Re: POLYFLOW MANUFACURING
10800 Gibson Avenue SE
Approval of Permanent Certificate of Occupancy (C.O.)
Engineer's Stamp dated 12/09/2006 (M-21/D7A1)
Certification dated 10/06/2005

RE: Ktech Polyflow manufacturing as built Grading and drainage plan

Re: POLYFLOW MANUFACTURING (M-21/D7A1)
10800 Gibson Blvd. SE
Request for Permanent Certificate of Occupancy (C.O.)

RE: Polyflow Manufacturing, Grading and Drainage plan and report
Engineer's stamp dated 6-02-05 (M21-D7A1)

1 HCP PARKING SPACE PLAN

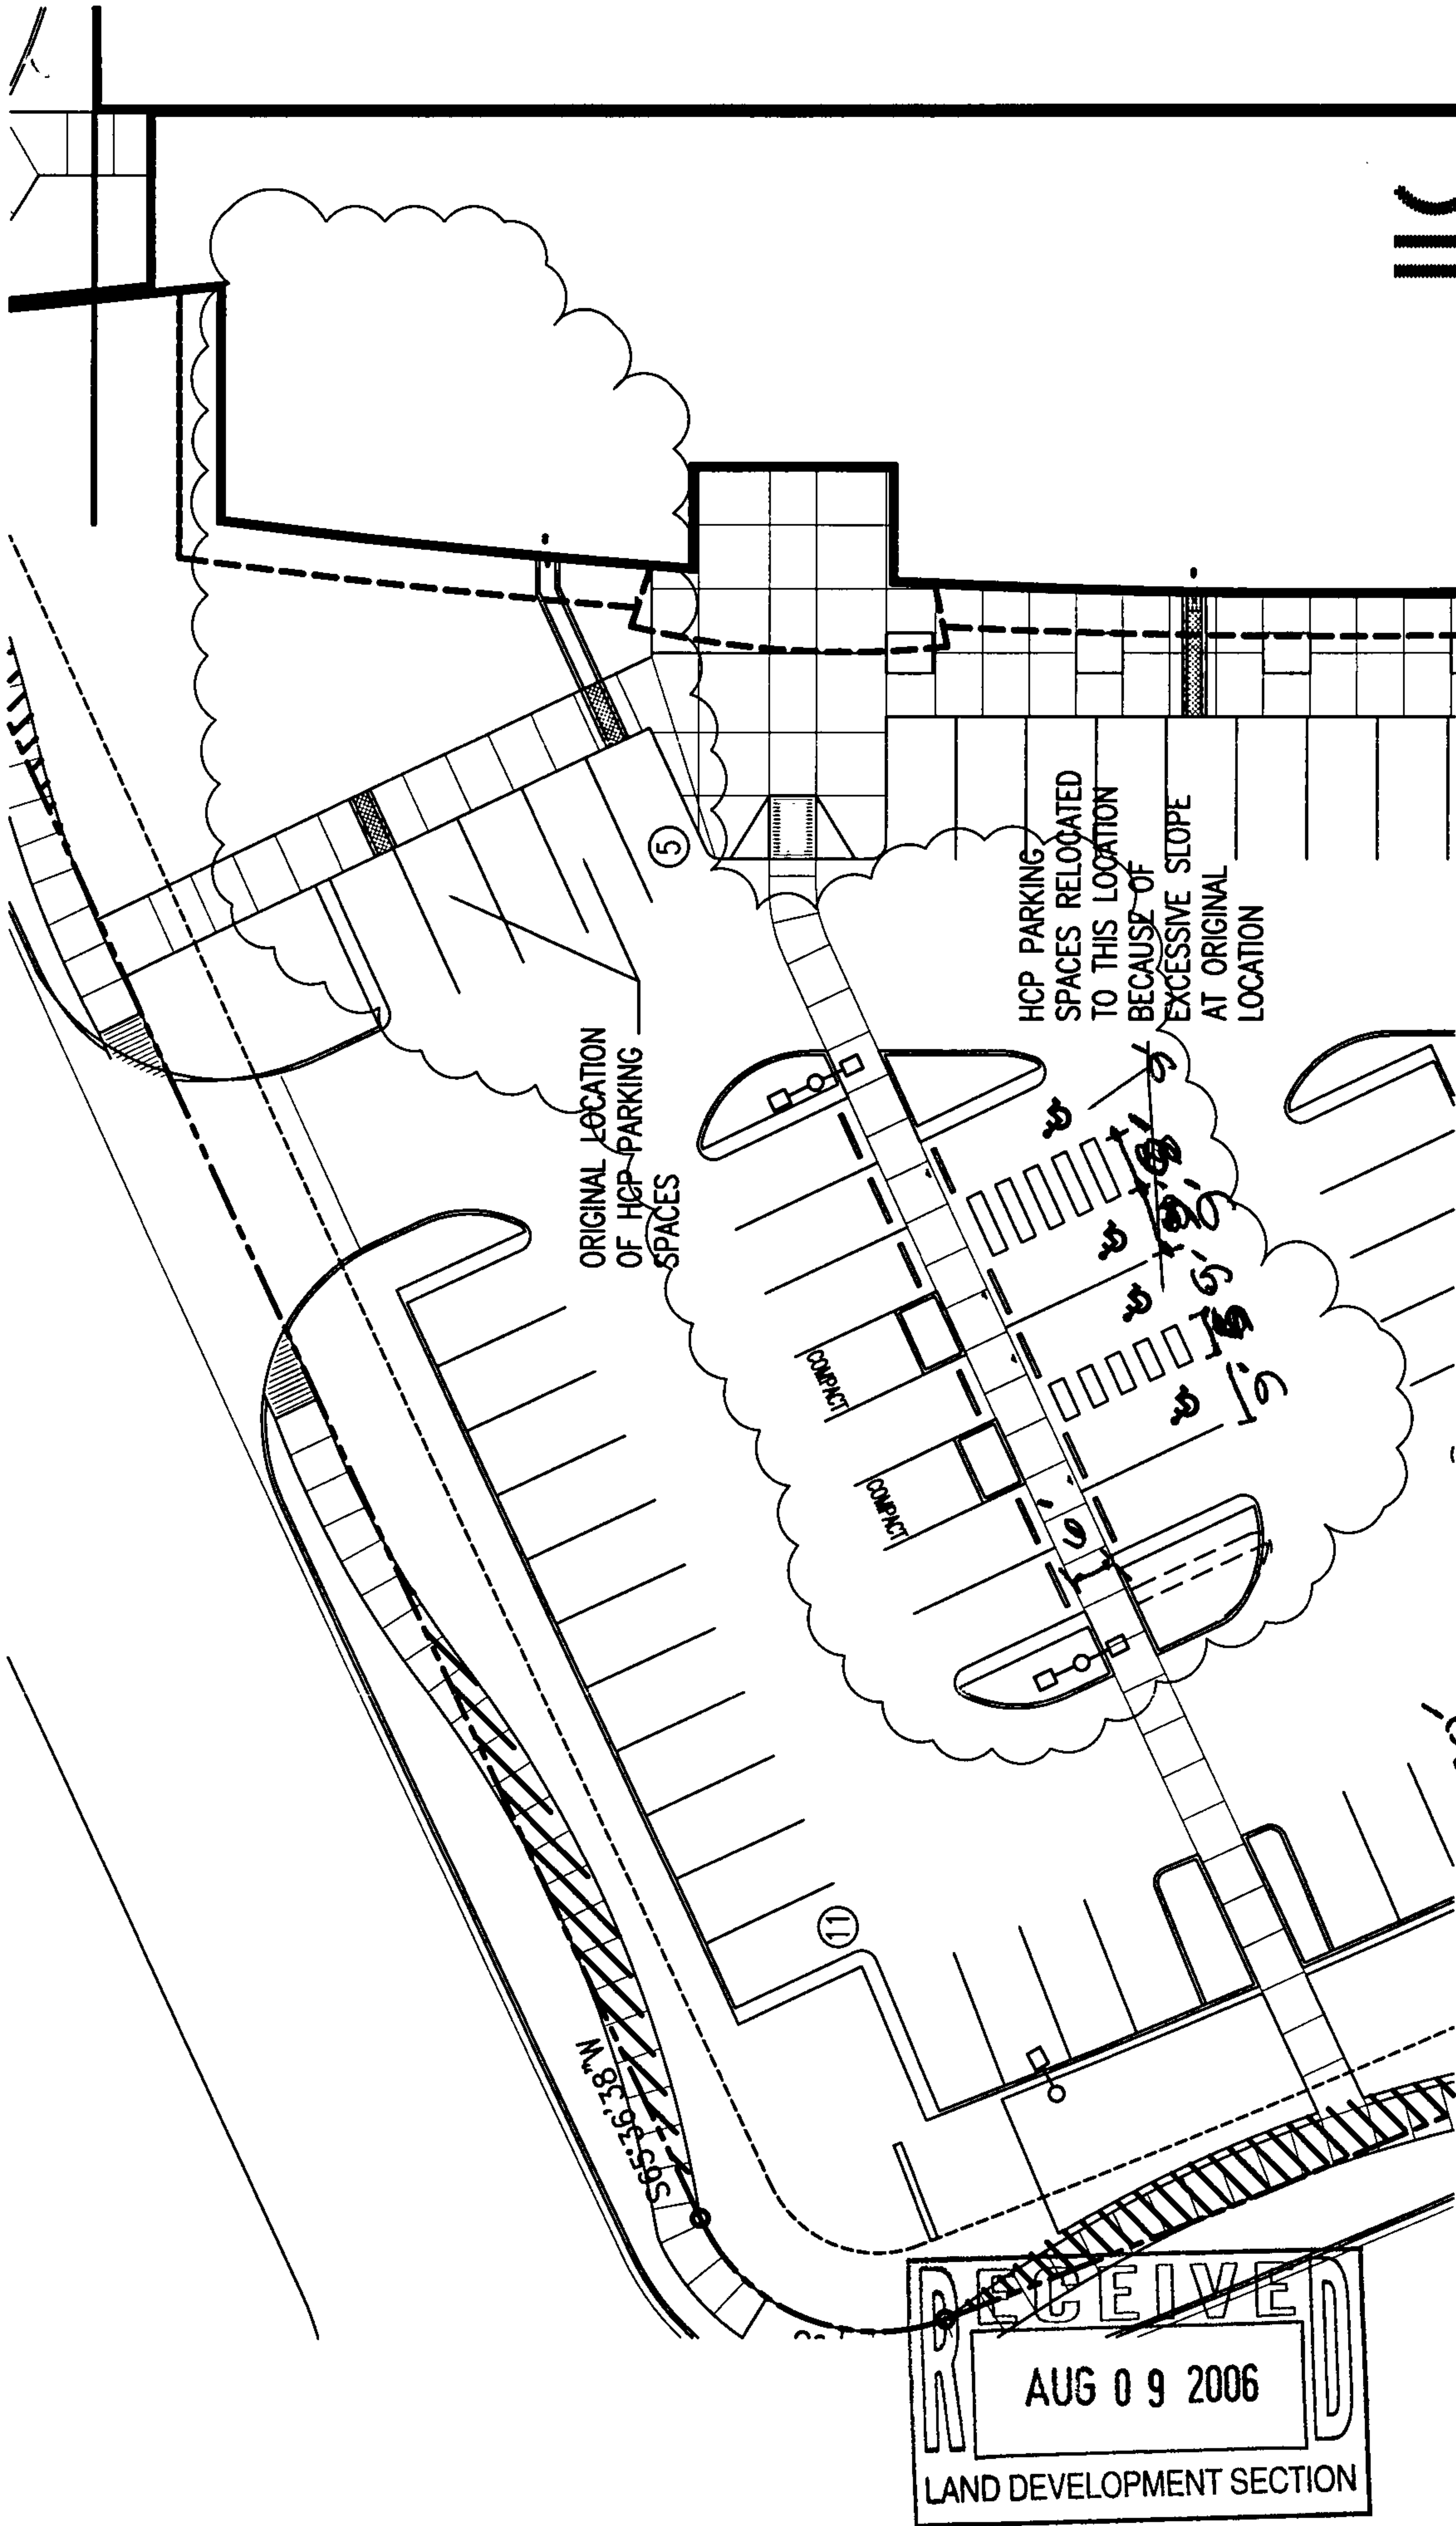
Nilo,
The only revision from the approved site plan was the re-location of four handicap spaces because the cross slope at the original location exceeded code requirements. The attached sheet shows the change and the current location of the HCP spaces. Let me know if you need more information.
